## Product Change Notice (PCN)

PCN Number: **PCN-0451150R-01**

Product(s) Affected: PJ-037AH

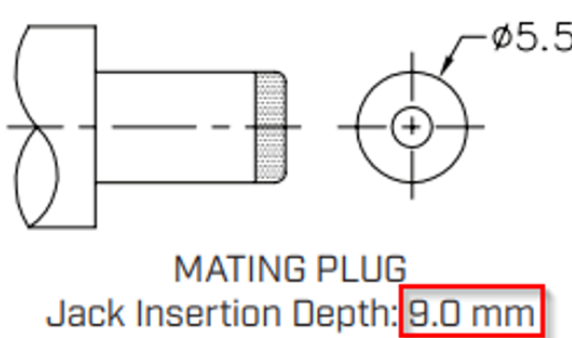
Description of Change: mechanical differences as shown below:

MATERIAL	PLATING
center pin	copper	nickel
terminal 1	brass	silver
terminal 2	copper alloy	silver
plastic	PBT

DESCRIPTION	MATERIAL	PLATING/COLOR
center pin	copper alloy	nickel
terminal 1	brass t=0.3 mm	nickel-silver
terminal 2	phosphor bronze t=0.3 mm	nickel-silver
housing	PBT (UL94V-0)	black
cover	PBT (UL94V-0)	black

**MATING PLUG**  
Jack Insertion Depth: 9.0 mm

**MATING PLUG**  
Jack Insertion Depth: 9.8 mm

Insertion/extraction force adjusted to 0.3 ~ 2.0 kg
